NEW YORK HARBOR
CHANNEL NAVIGATION IMPROVEMENT 50 FT PROJECT
AMBROSE CHANNEL

CONTRACT2
S–AM–1
W912DS–05–B–0012

Symbol	Description	Date	Rev.
4	Sheet C-35 and C-37 are eliminated and sheet numbers are rearranged accordingly. I thru 35 and Alignment Data sheet All Plan Sheets and Cross sections sheets are revised.	7/19/05	G.A.

COVER SHEET,GENERAL PLAN AND INDEX TO DRAWINGS

PLAN SHEET STA605+48.7 TO STA666+00

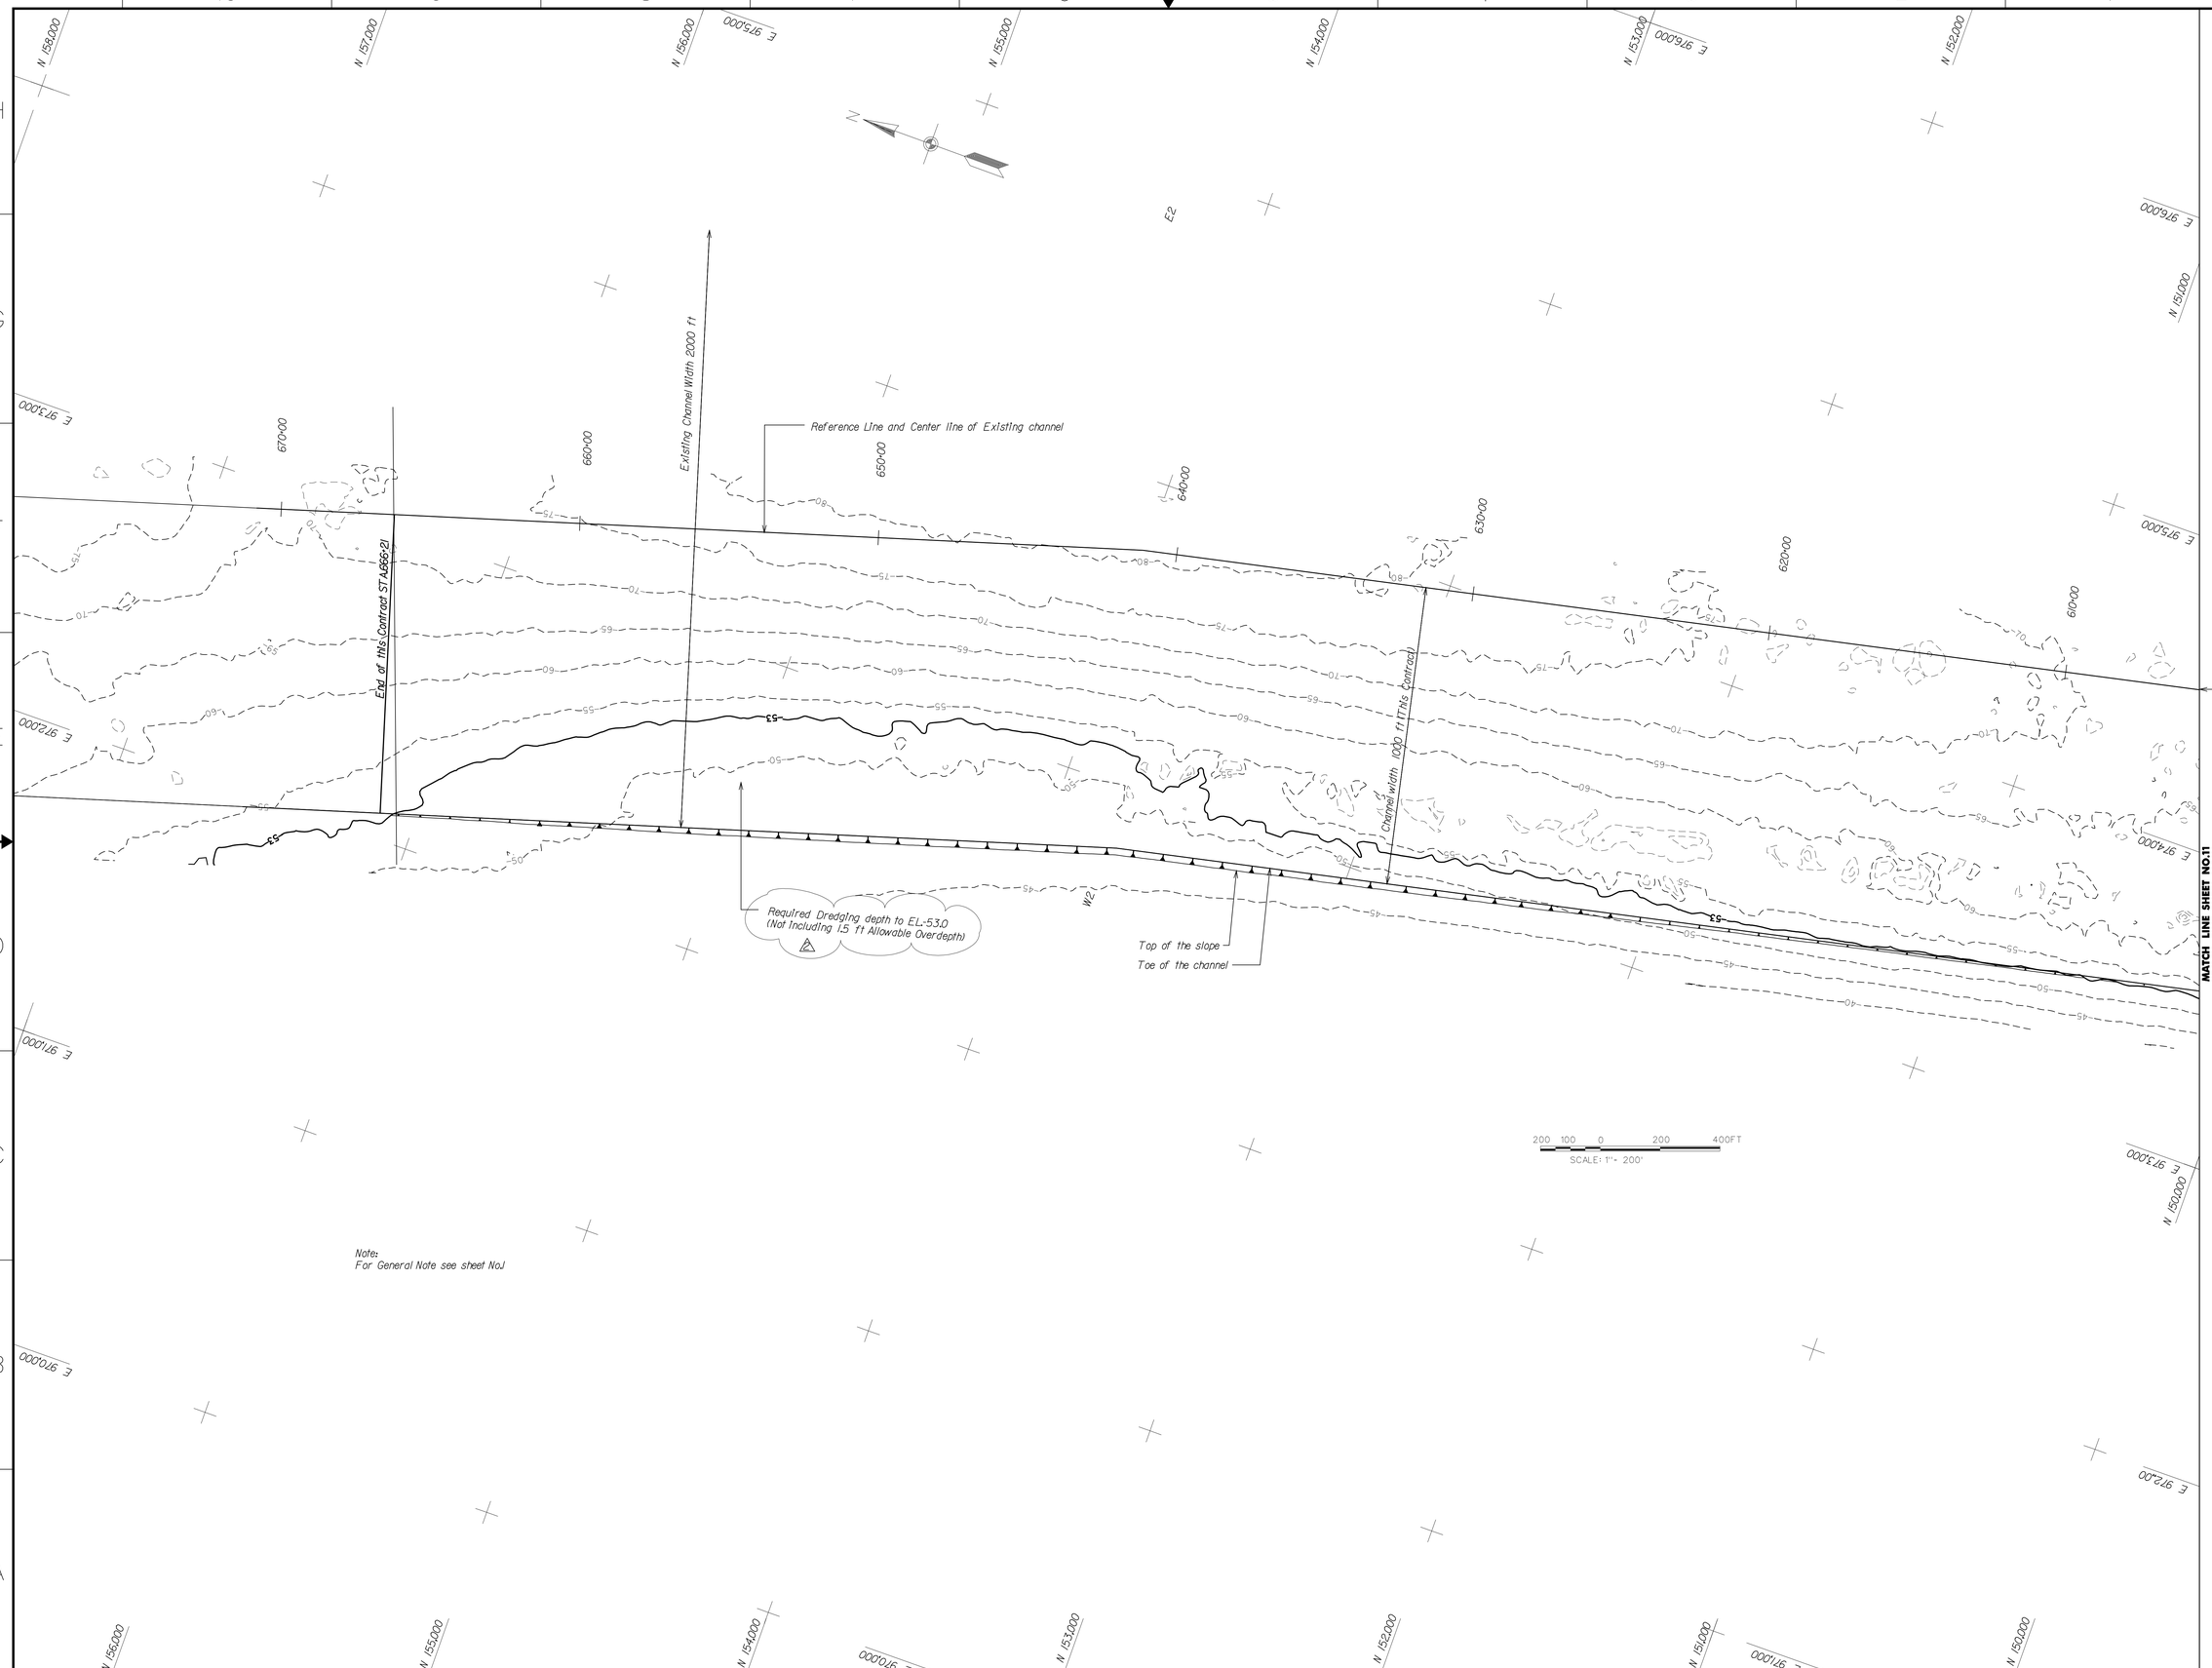
Date	Description	Drawn	Chk'd
7/19/05	Revised Allowable Overdepth	G.A.	Peer

CROSS SECTIONS STA.336+00 TO STA.484+00

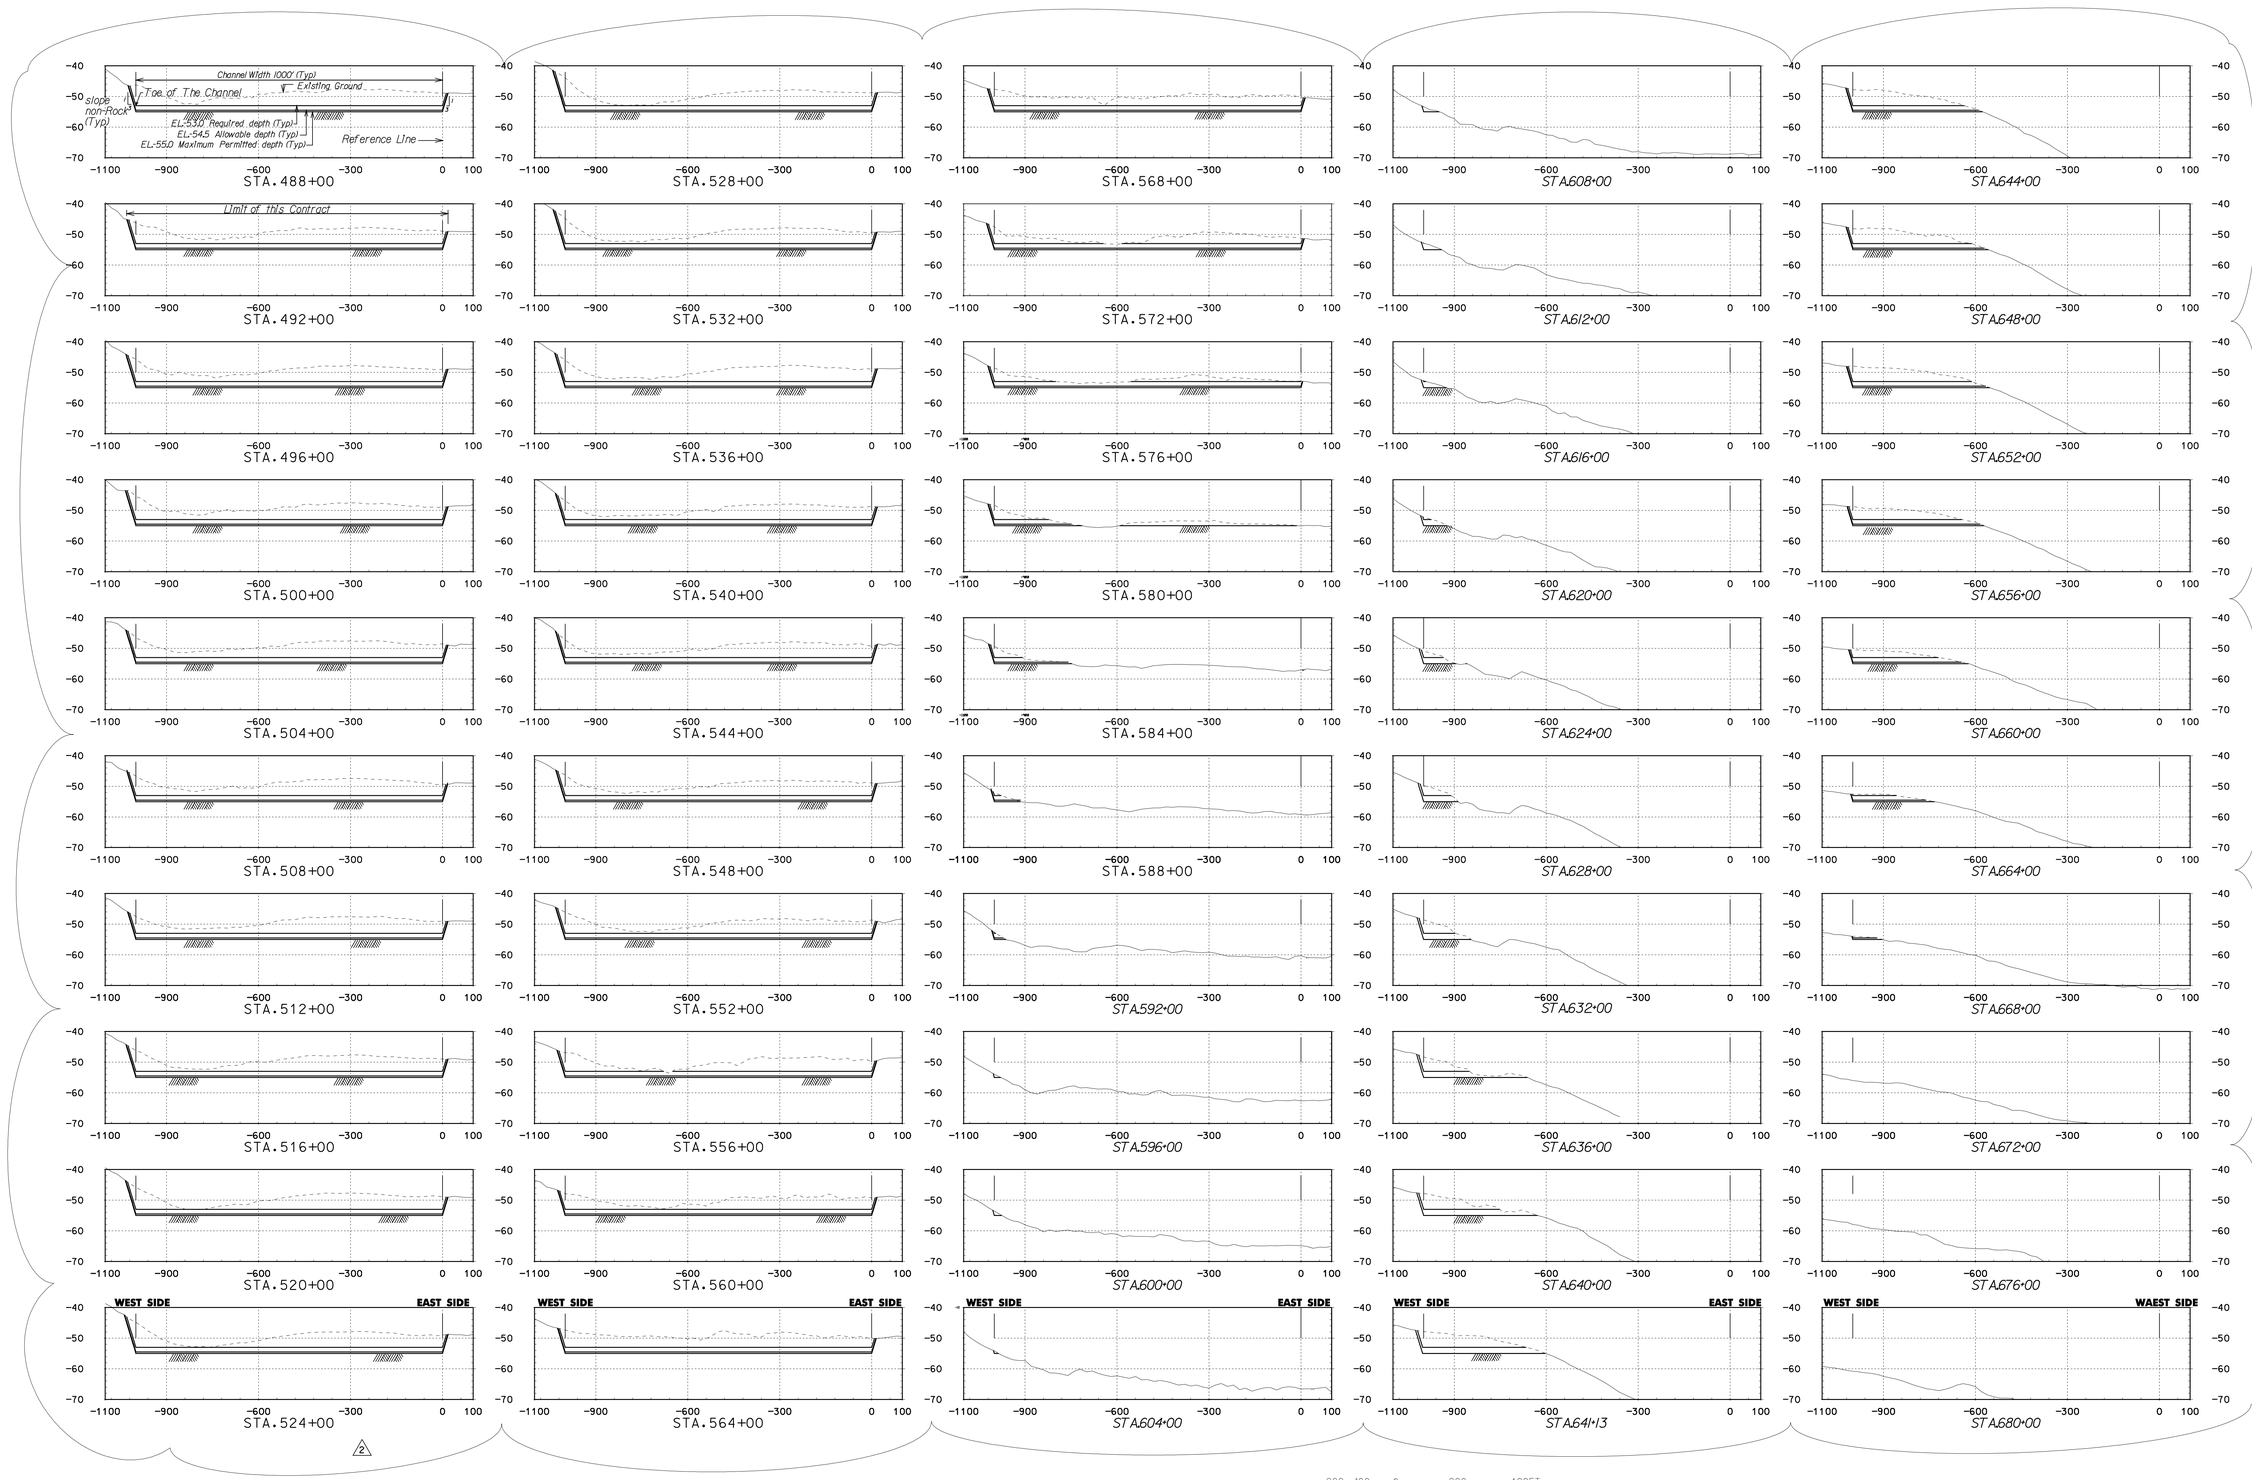
Symbol	Description	Date	Rev.
2	Allowable overdepth is Revised to EL-44.5 and Unpaid maximum 5 ft allowable overdepth is revised to EL-55.0	7/19/05	G.A.

CROSS SECTIONS STA.488+00 TO STA.680+00

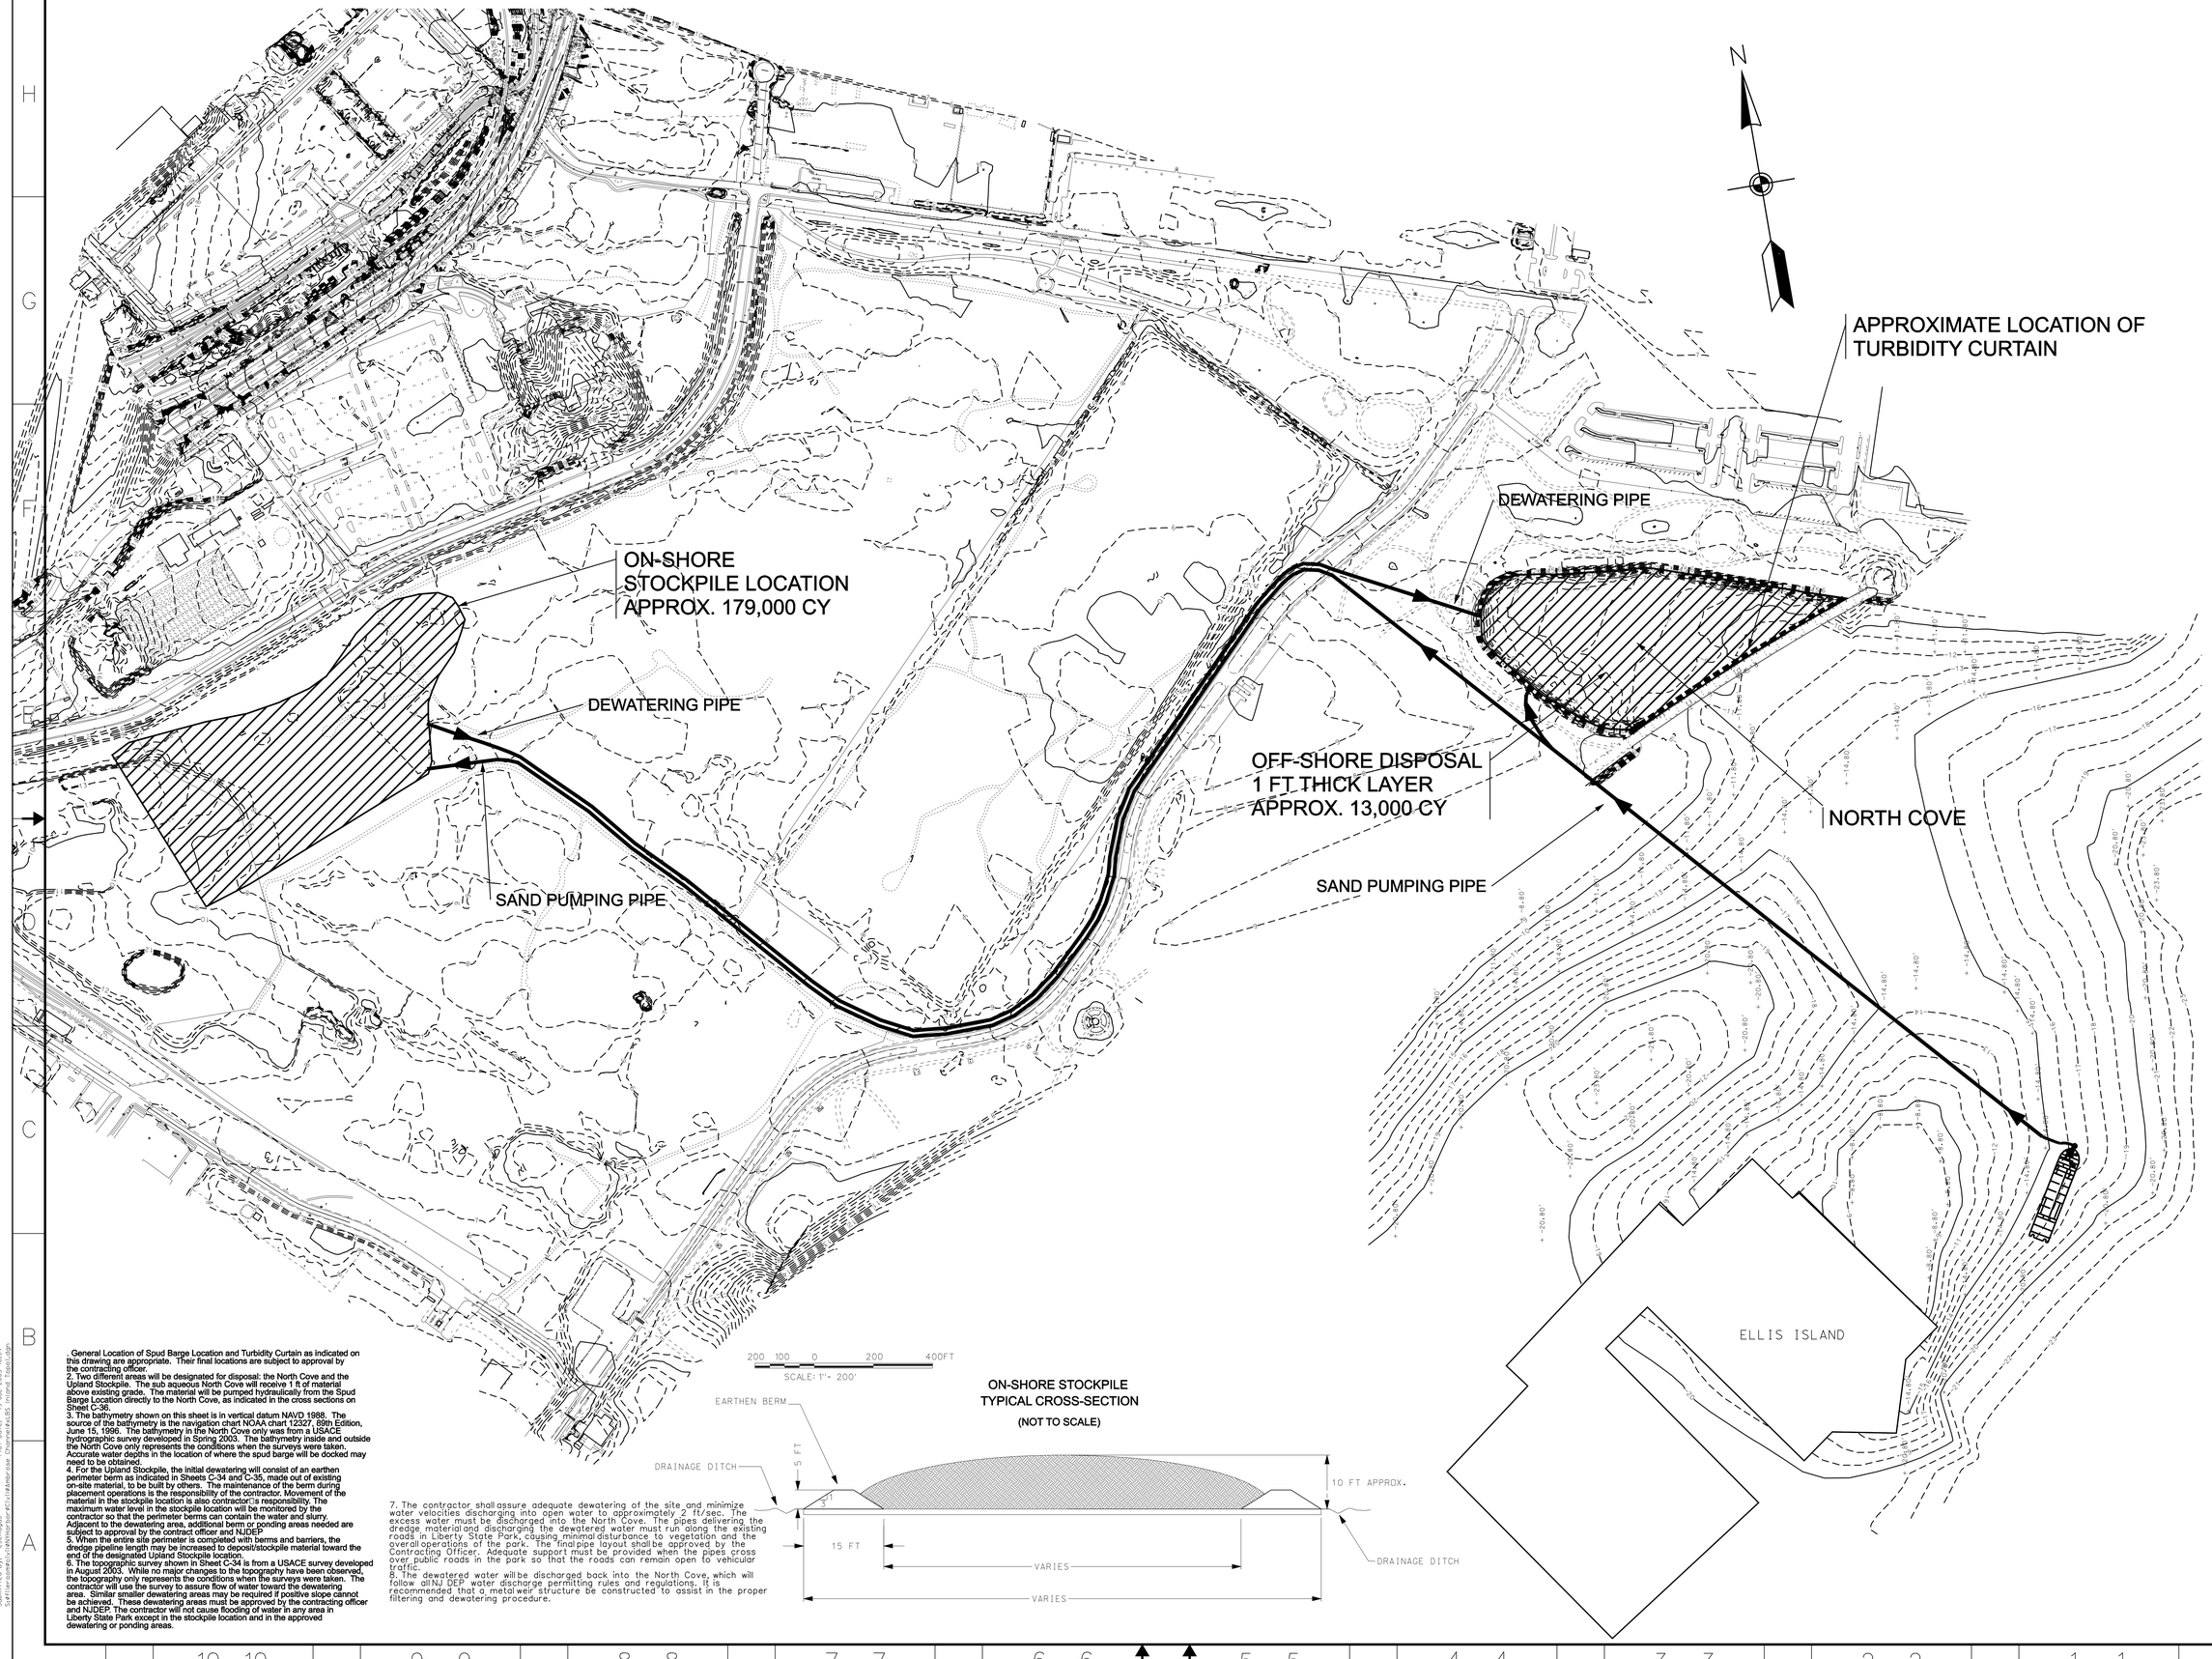
Rev.	Date	Description	Drawn	Appd.
2	7/19/06	Allowable overdepth is revised to EL-545 and Maximum 1.5 ft) unpaid allowable overdepth is revised to EL-550	G.A.
